Product Change Notification - SYST-12XLUL037

ERRATA - PIC32MZ Graphics (DA) Family Silicon Errata and Data Sheet Clarification

PIC32MZ Graphics (DA) Family Silicon Errata and Data Sheet Clarification

FIGURE 1: Posc CRYSTAL CIRCUIT

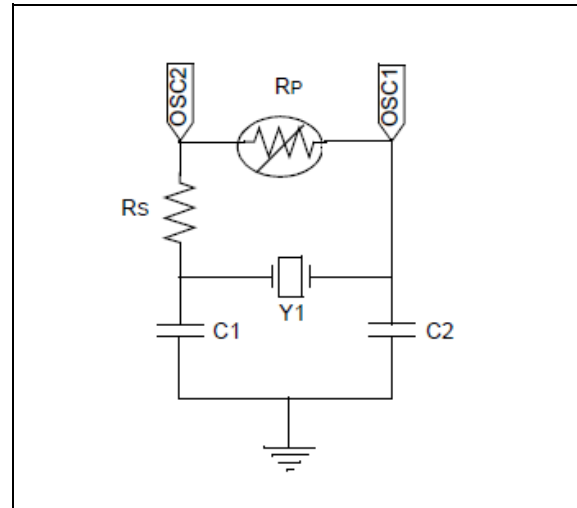
1. Module: Primary Oscillator

The POSC has been tested in a normal power-up sequence and supports specific crystal operation.

The Primary Oscillator (POSC) has been characterized to operate at 8 MHz and 12 MHz when the circuit shown in Figure 1 is implemented, and the operating conditions listed in Table 3 are met.

FIGURE 2: EXTERNAL RESET CIRCUIT

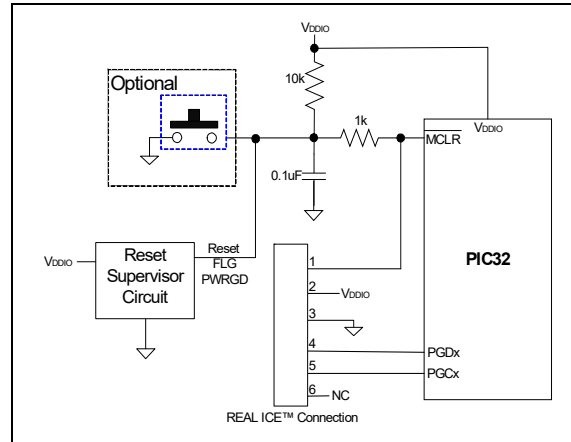
3. Module: Reset

A system Reset is not generated on a BOR event ($V_{PORIO} < V_{DDIO} < V_{BORIO}$). This will stop system clocks with all the I/O pin functions frozen in the present state until either V_{DDIO} falls to V_{PORIO} or $V_{DDIO} > V_{BORIO}$.

Reset device using a \overline{MCLR} pin through an external reset supervisor/monitor is shown in Figure 2. Set the SMCLR (DEVCFG2<15>) configuration bit to '0', which makes the \overline{MCLR} to act as a POR Reset instead of a normal system reset.

When selecting an external supervisor other than the ones provided in Table 4 and Table 5, the following requirements must be taken into consideration:

- Minimum Reset trip voltage of the external supervisor should be $V_{BORIO} (Max) + 0.5V$.
- The external reset supervisor/LDO output going to \overline{MCLR} should have an open drain output to not interfere with the MPLAB programming/debug tools.

When this work around is implemented, the minimum V_{DDIO} operating voltage of the application needs to be above the reset supervisor maximum trip voltage + 0.2V, where 0.2V compensates for variation in the external reset supervisor voltage.
